SUBJECT: Limerick Generating Station, Units 1 & 2  
Additional Information for Auxiliary Systems  
Branch Regarding SER Open Issue #2 (Tornado  
Missile Effects on Ultimate Heat Sink)

Attached is a document entitled, "Responses to Questions and Requests for Additional Information on NUS-4507 Report 'Limerick Generating Station UHS Extreme Wind Hazard Analysis'", dated September 1984".

RESPONSES TO QUESTIONS AND REQUESTS FOR  
ADDITIONAL INFORMATION ON  
NUS-4507 REPORT

"LIMERICK GENERATING STATION UHS EXTREME WIND HAZARD ANALYSIS"

Figure 1. Limerick Hazard Curves for Hurricane and Straight Winds

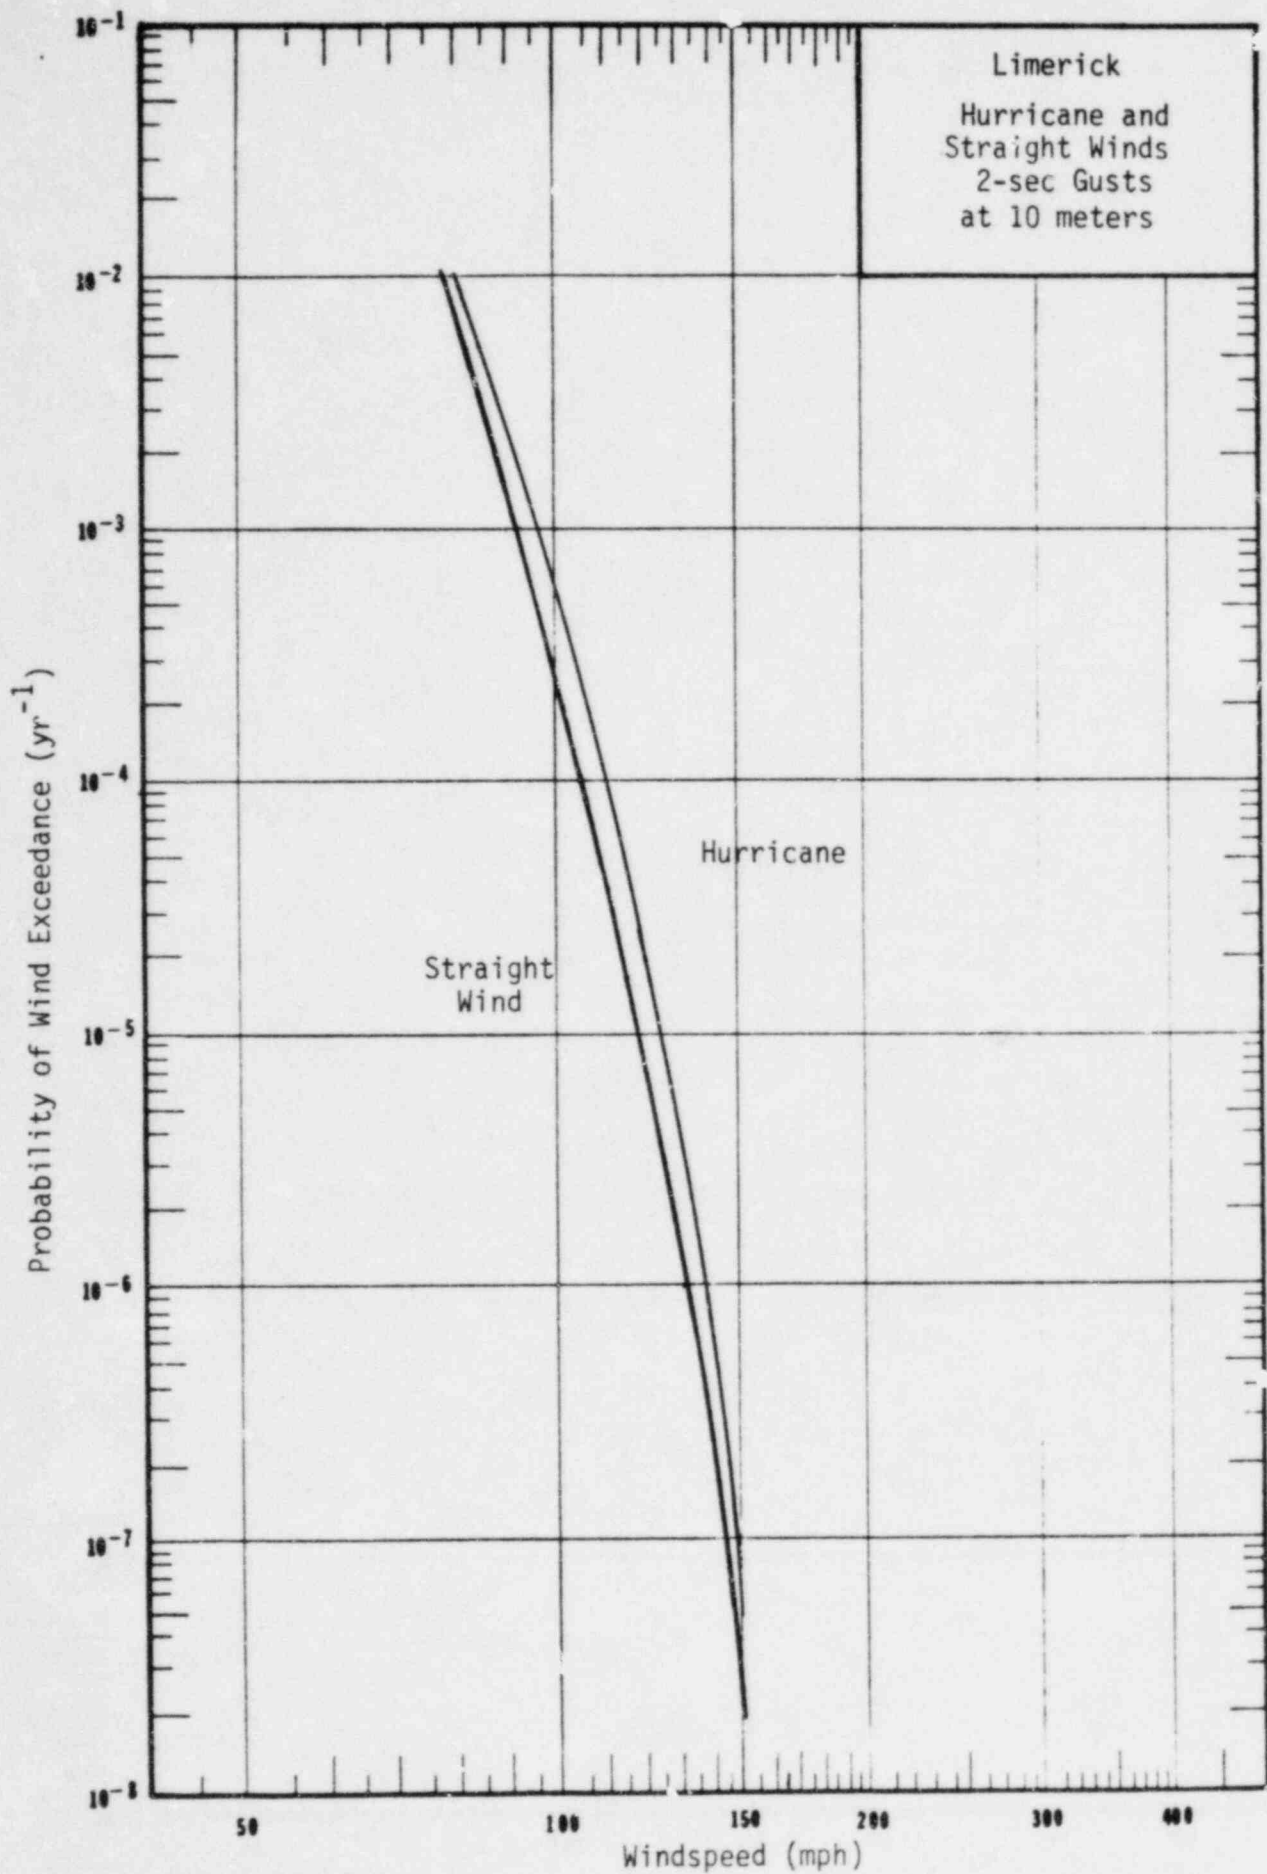
Q.6 What is the value of the hurricane and straight wind speeds at an elevation of 33 ft. which correspond to the nominal failure of the cooling towers? Can it be shown that the probability of failure of the cooling towers due to missiles borne by straight winds and hurricanes with speeds less than this value is negligible when compared to a frequency of  $10^{-6}$  per year?

These frequencies are identical to the 78 and 102 mph data and are slightly conservative for the 70 mph data point in NUS-4507 [3]. The resulting curve is given in Fig. 1.

Table 1 summarizes these calculations and the resulting windspeeds for exceedance probabilities  $1 \times 10^{-1}$  to  $1 \times 10^{-6}$  per year. Figure 1 illustrates the straight-wind frequencies. These windspeeds correspond to 2-sec gusts, which are conservatively assumed to be of sufficient duration to fail the cooling towers.

The effects of straight winds on the UHS and cooling towers at Limerick can be conservatively estimated from the results in Table 2. The entries for each windspeed interval are adjusted by the ratio of occurrence rate of straight winds to hurricane winds. From Fig. 1 and the preceding table, the straight wind frequencies and adjustment factors are approximately:
